This is my testimony concerning the proposed Zelman#1 injection well to be located off Tower Lane, in Brady Twp., Clearfield Co., Penna. 15801. (Permit App. # PAS2D020BCLE).

Windfall/Zelman #1 DIW ~ Permit # PAS2D020BCLE

RE: UIC Permit PAS2D020BCLE (Windfall/Zelman 1)

Attachment "M" Construction Details -subsurface Zelman#1 Injection Well ZELMAN WELLBORE SCHEMATIC

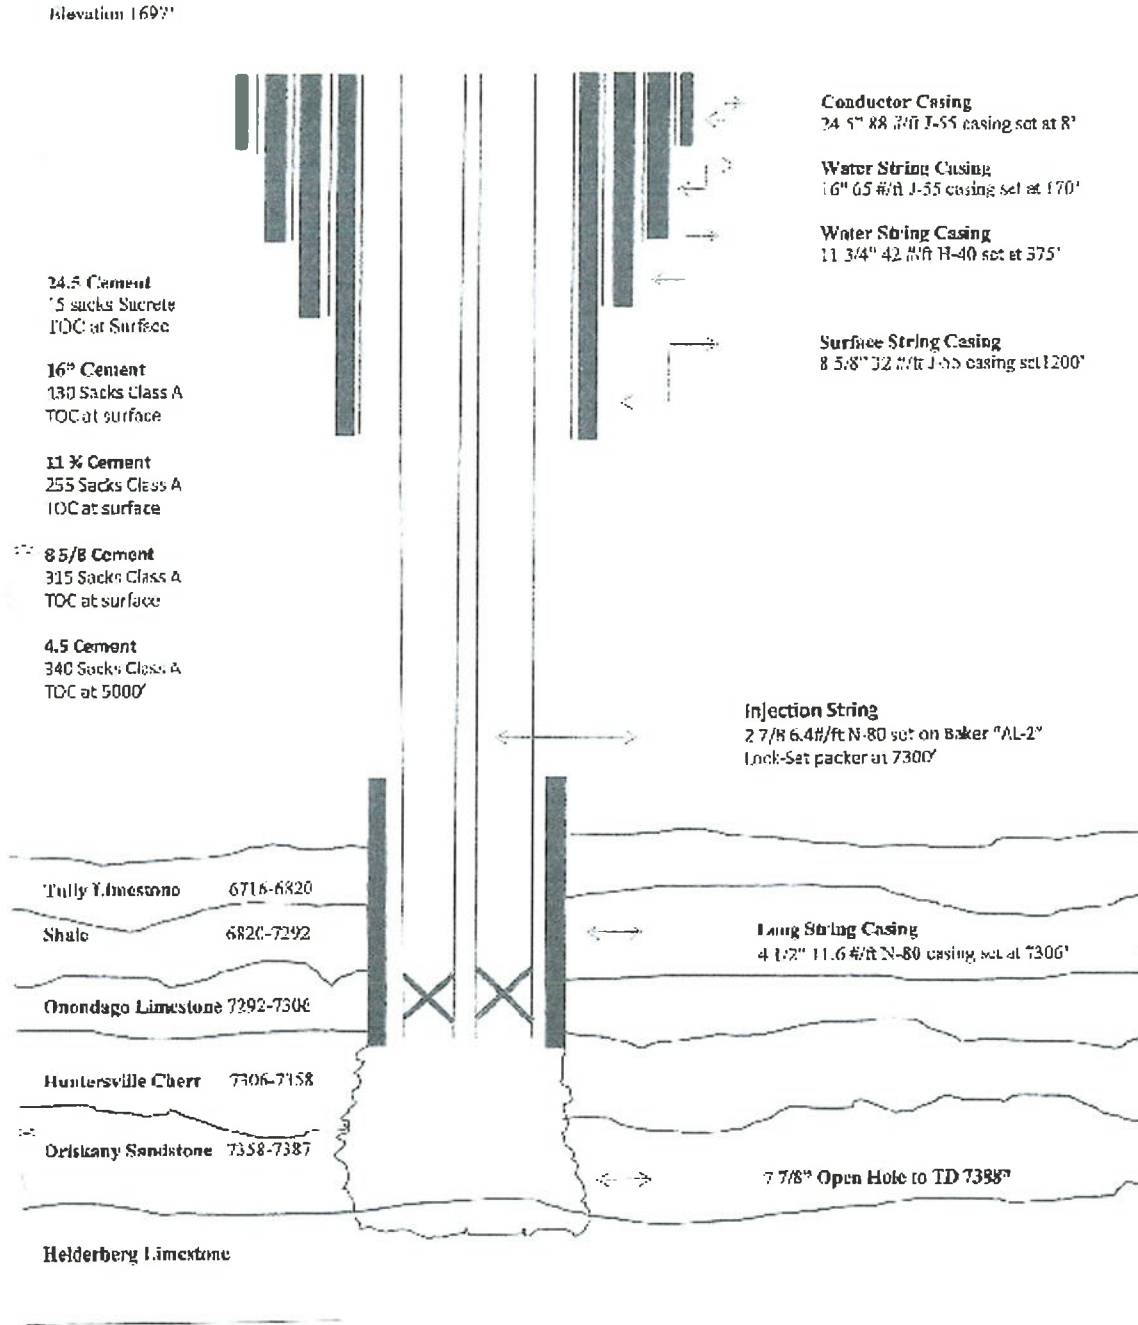
Comment: The draft permit (see attachment #1) specifies a simpler casing and cementing system than what was proposed by Windfall Oil & Gas in their permit application (see attachment #2). The EPA should change their casing and cementing requirement to include a 2nd ground water protective string of casing installed from the surface to a depth of 375 feet and cemented back to the surface.

In my opinion, the permit should require the Zelman injection well to be constructed according to the proposed casing and cementing plan which has 5 telescopic layers of casing outside of the injection tube as opposed to the draft permit plan, which has only 3 layers of casing outside of the injection tube.

Table 1

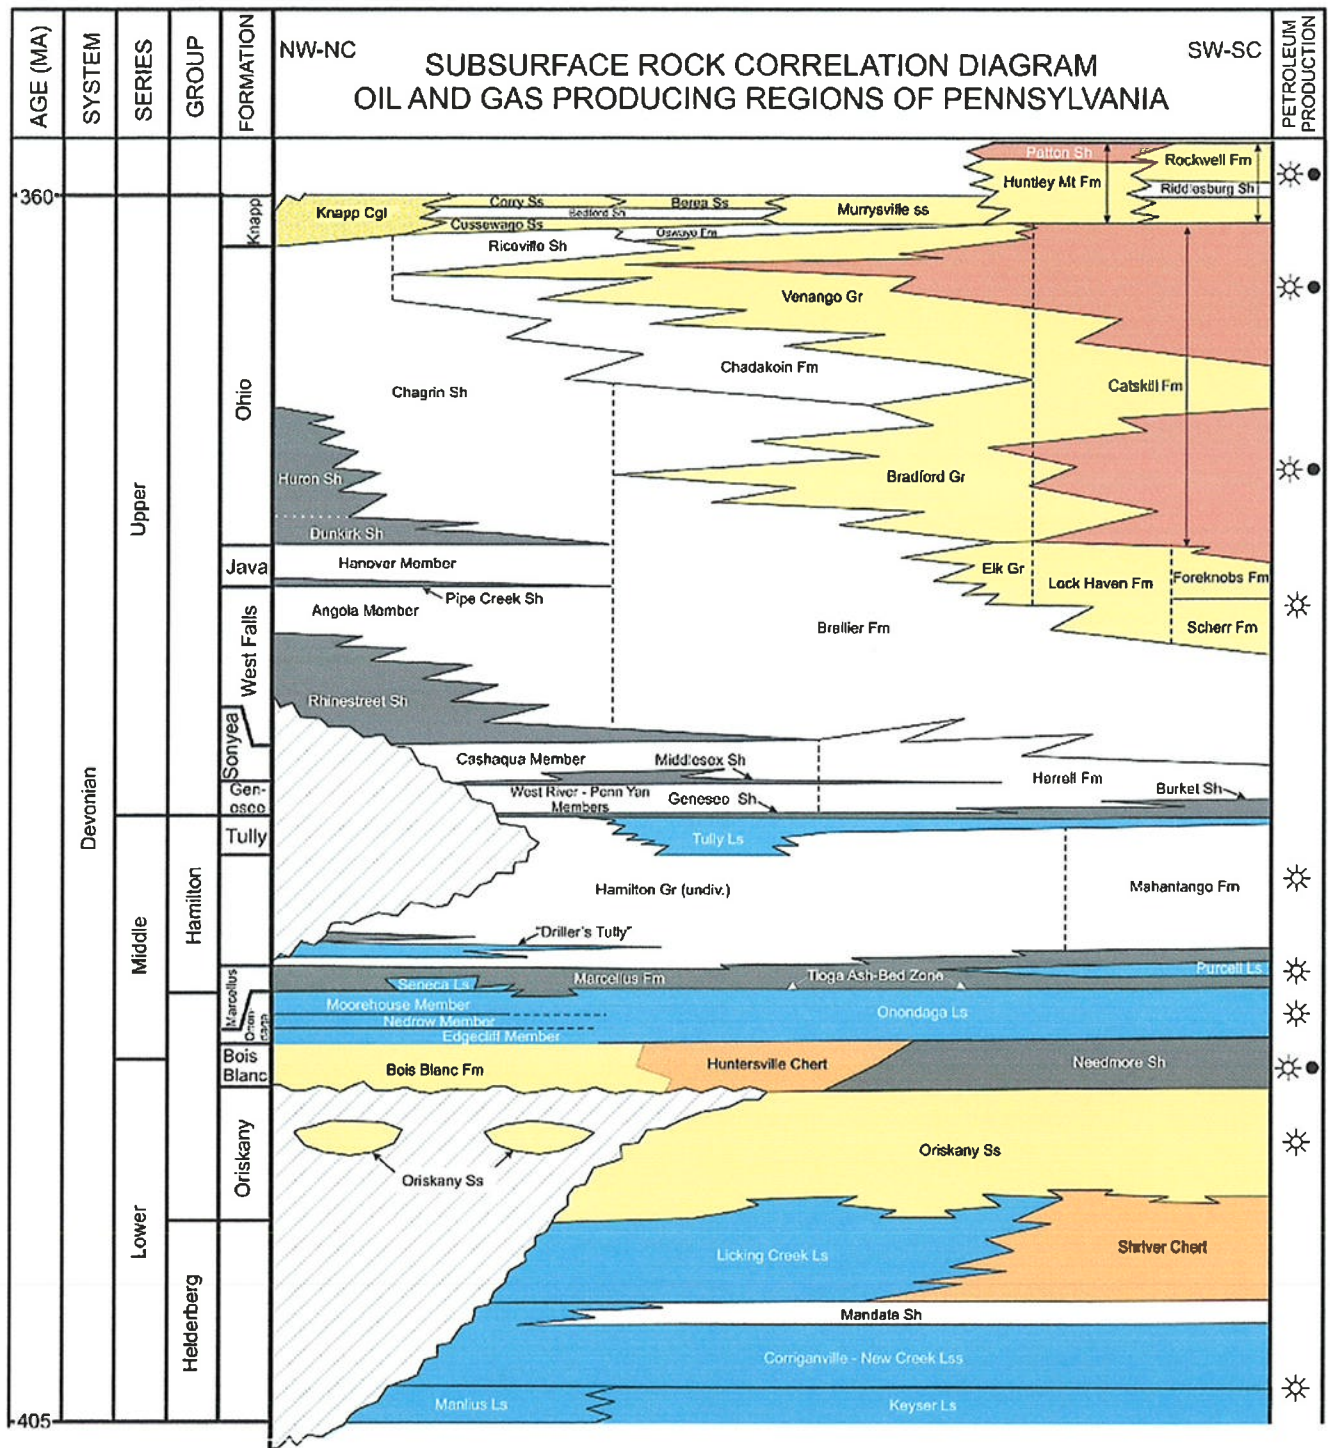
Comment: Based on 5 well records from nearby natural gas wells, the Onondaga Limestone confining zone, immediately above the Huntersville Chert/Oriskany injection zone, is only between 14 and 18 feet thick and **NOT** approximately 50 feet thick, as is stated in the Statement of Basis. In addition, the Huntersville Chert/Oriskany formation injection zone is 69 to 84 feet thick and not 87 feet as stated in the Statement of Basis.

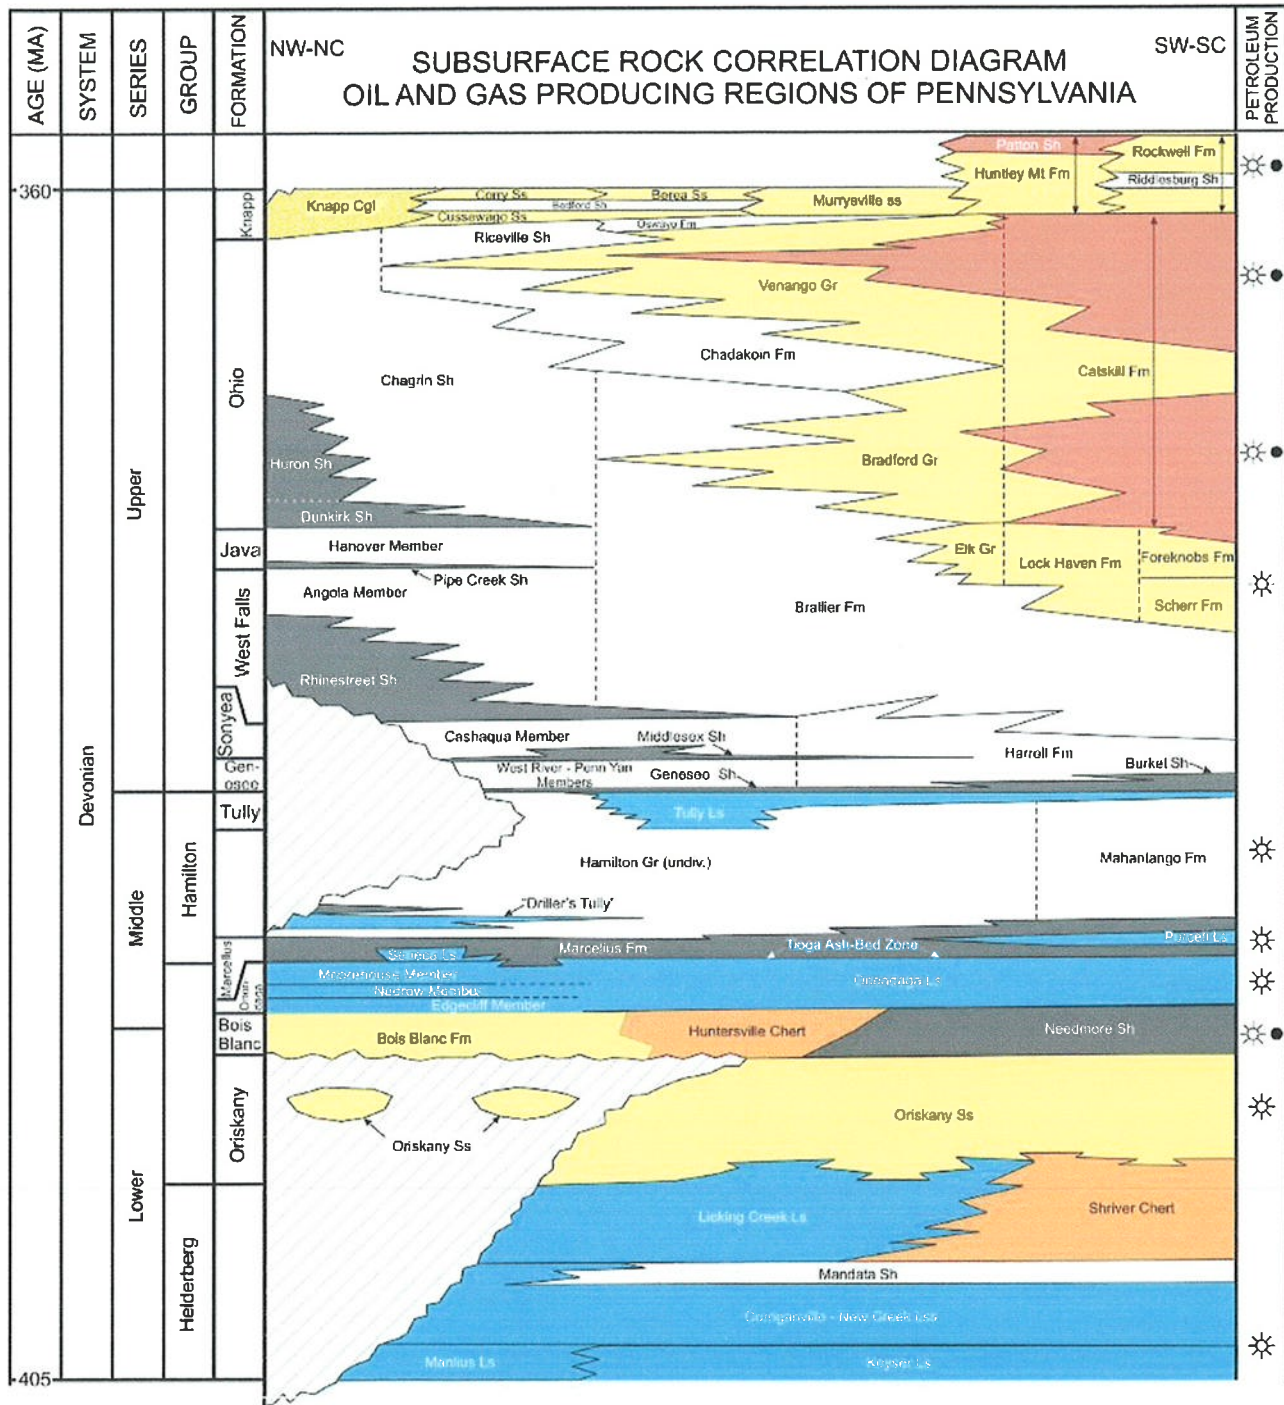
Comment: There are 2 deep conventional gas wells that are JUST outside the Area of Review, which go into the Oriskany formation, which is **also** the injection formation. Both of these deep gas wells have been fracked. The **Draft Permit** for the Zelman injection well states the following: ...**the injection well shall inject only into a formation that is free of known open faults and fractures within the Area of Review.**

How can we know that the fractures from fracking these gas wells do not compromise the confining layer and thereby violate the DIW construction requirements? These fractures could provide a conduit for toxic injected fluid to work its way into USDWs. (Underground Sources of Drinking Water)

Ginter/Deposit Bank gas well goes into the Oriskany Sandstone and was fracked on December 22, 1960 and is 161 feet outside Area of Review to the **north**

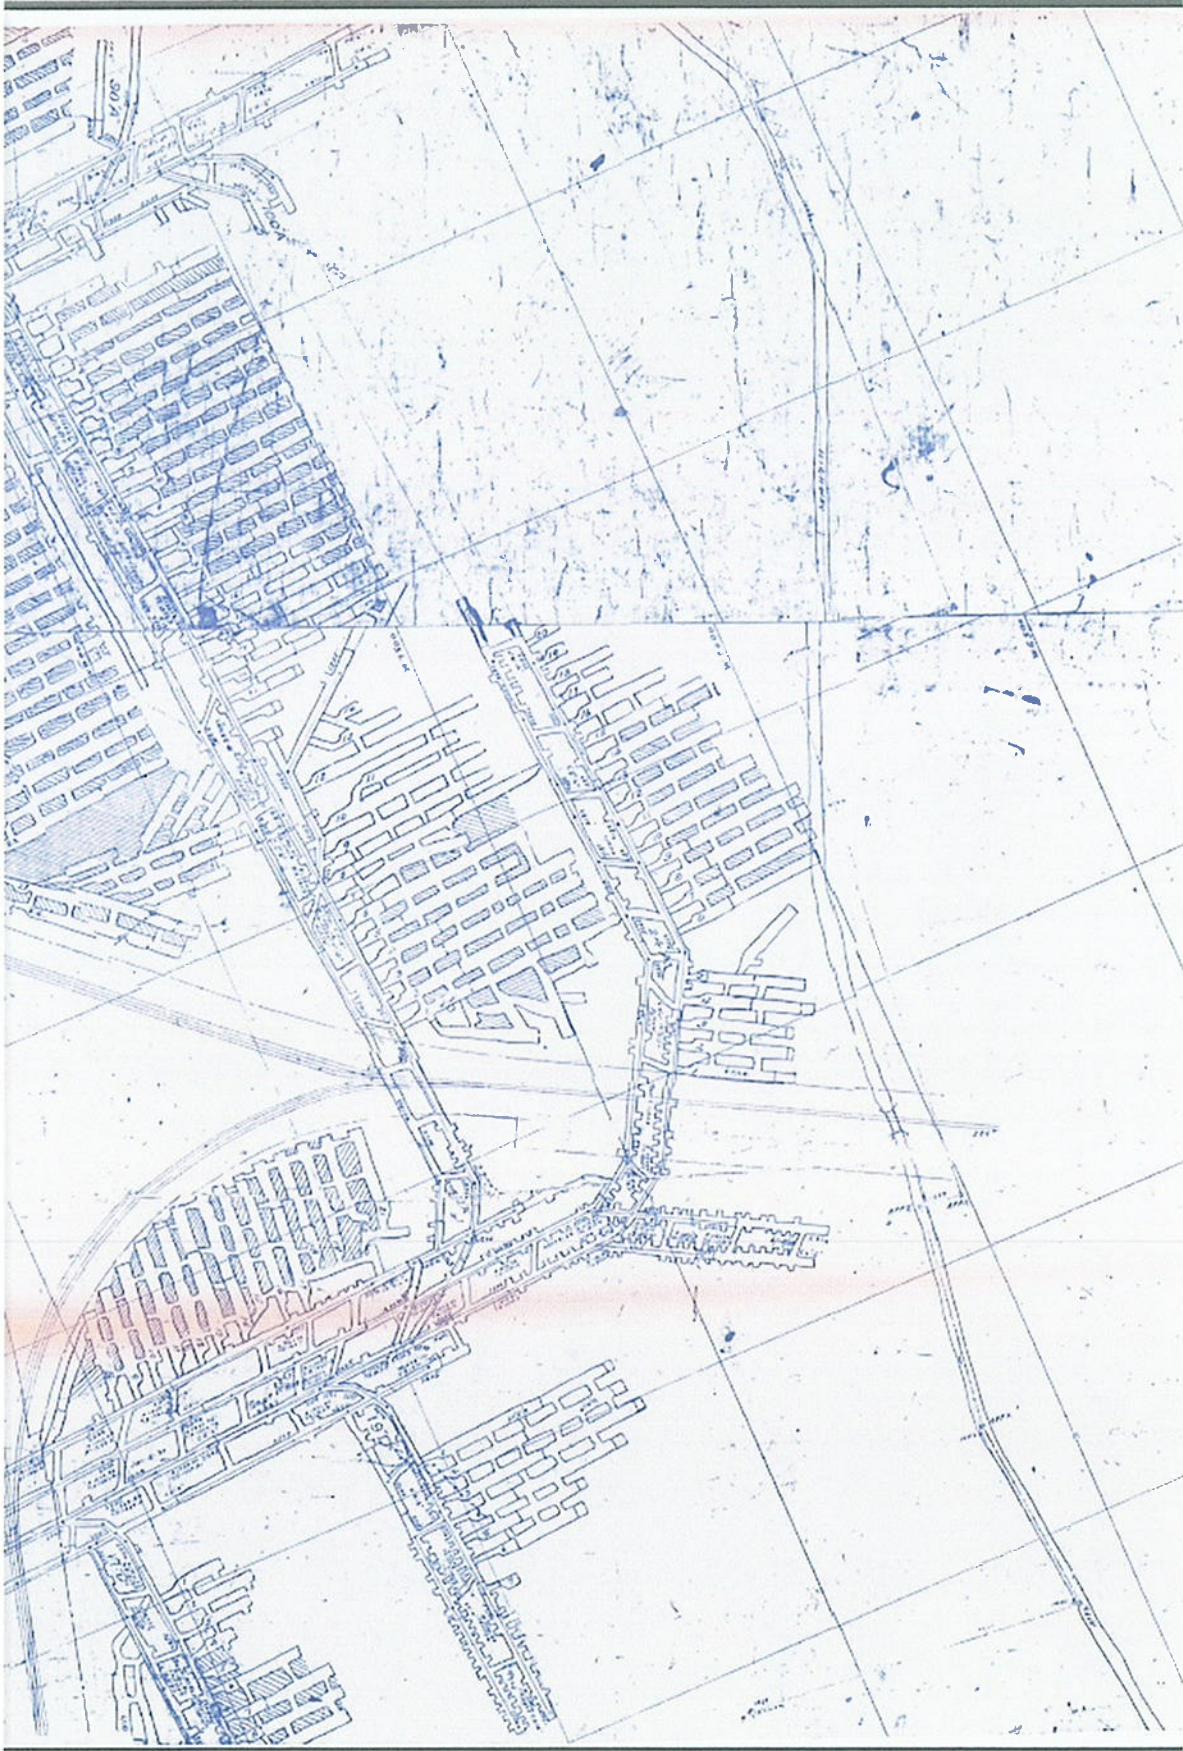
Comment: There is no single topographic map extending one mile beyond the Zelman property boundaries and no indication that there are subsurface mines within the Area of Review. Therefore, the application is deficient.

I went to the DuBois Public Library and examined the permit application. I did not find a single topographic map extending one mile beyond the property boundaries.

Furthermore, there are approximately 6 acres of subsurface mines within the western side of the area of review. Nowhere in the permit application materials is the presence of these mines shown on a map or even mentioned.

Attachment #1 ~ PA DEP map of subsurface mines within Zelman DIW Area of Review

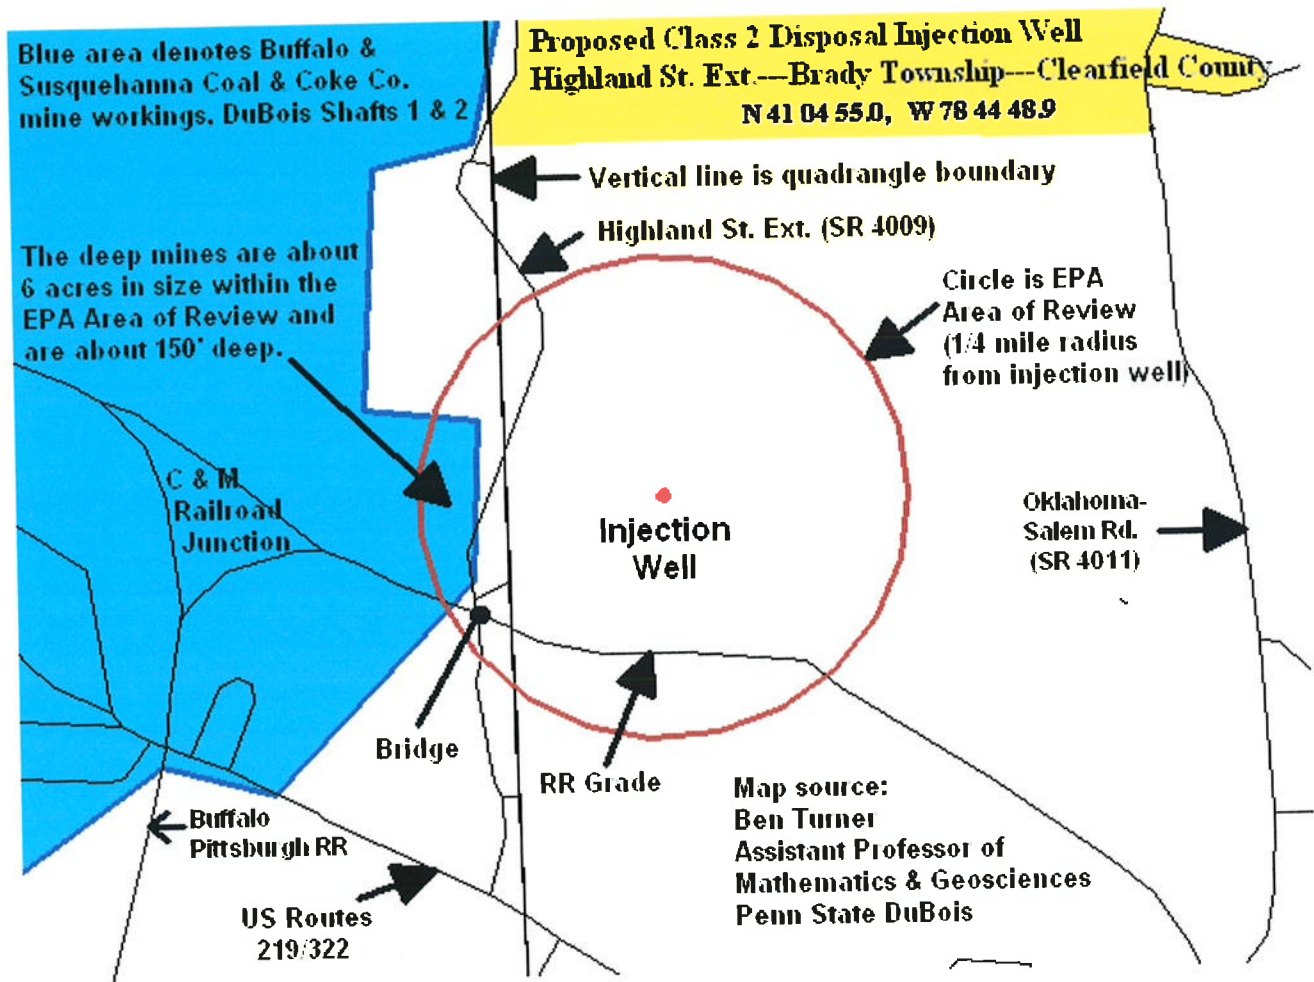
Maps of these subsurface mines are publicly available from the PA DEP District Mining Operations, California District Mining Office (see attachment #1).
